UNITED STATES PATENT AND TRADEMARK OFFICE

| 10/619,648               | 07/14/2003  | Steven Robert Hetzler | ARC920030040US1     | 8642             |

| <b>Office Action Summary</b> | <b>Application No.</b> | <b>Applicant(s)</b> |  |

## **DETAILED ACTION**

FIG. 1

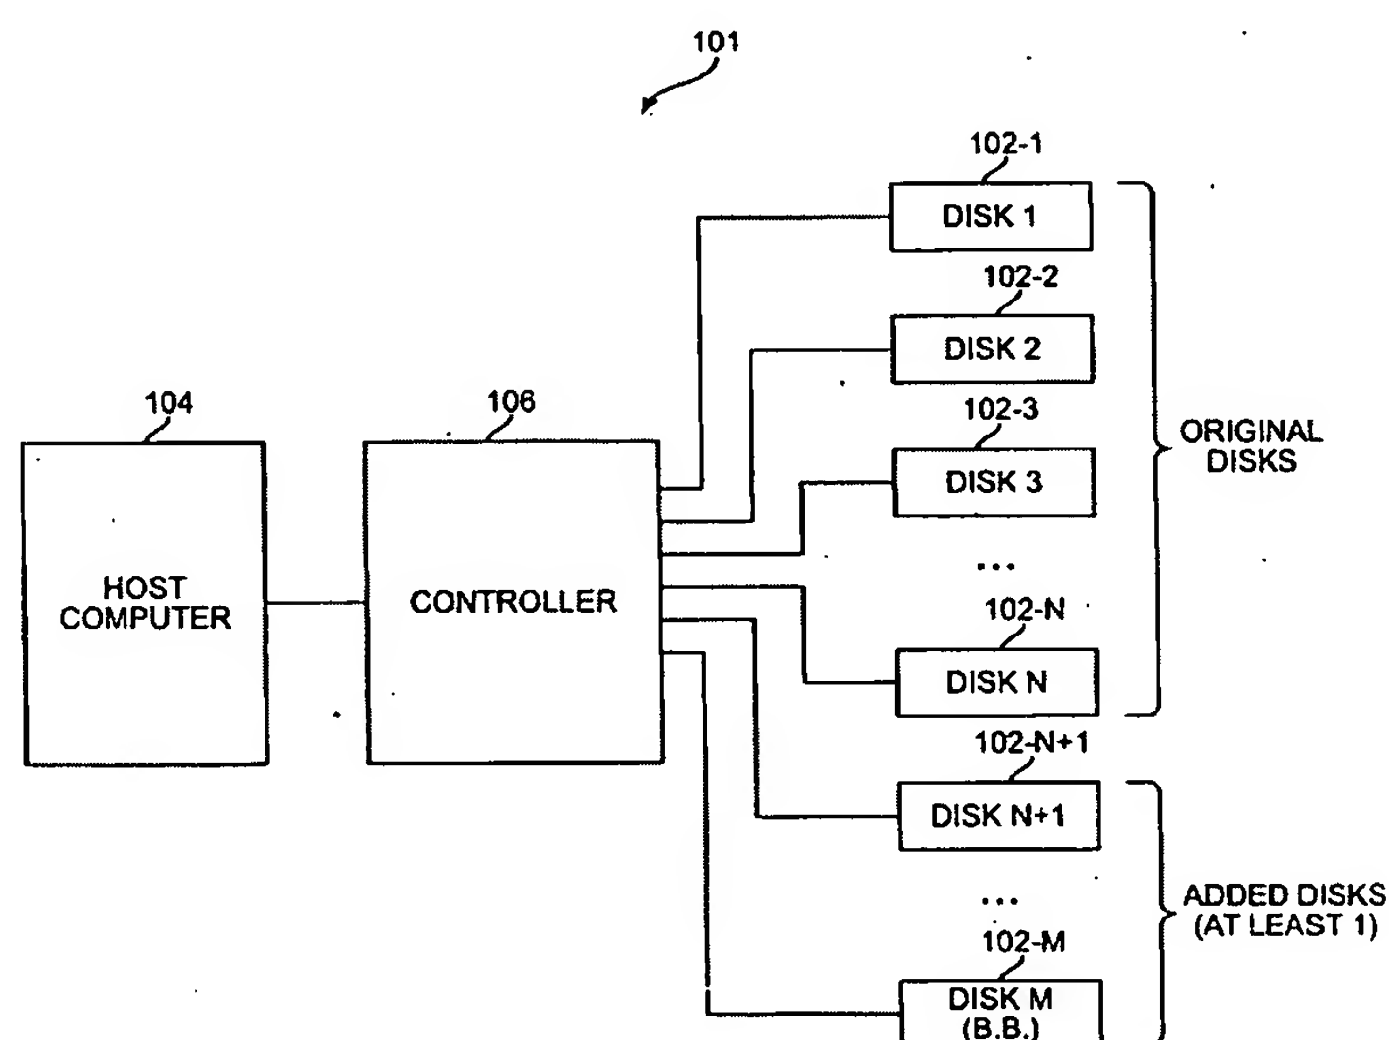
destination storage devices; repeating the steps of migrating, copying, and mirroring, until data that will be in the destructive zone is migrated out of the destructive zone; and migrating remaining data from the source disks onto the destination disk. Particularly, King teaches Figure 1 an array controller 106, a plurality of original disks N (analogous to data storage units) and a plurality of added disks M (analogous to check storage units).

King does not explicitly teach to have three storage units and three check units as stated in the present application.

However, the Examiner would like to point out that have exactly three storage units and three corresponding check units is a matter of obvious engineering design choice. Therefore it would have been obvious to limit the number of storage units and number of corresponding check units in King to three as is suggested in the present application. This would have been obvious since three is a number, which is included in a plurality as is taught by King. Further
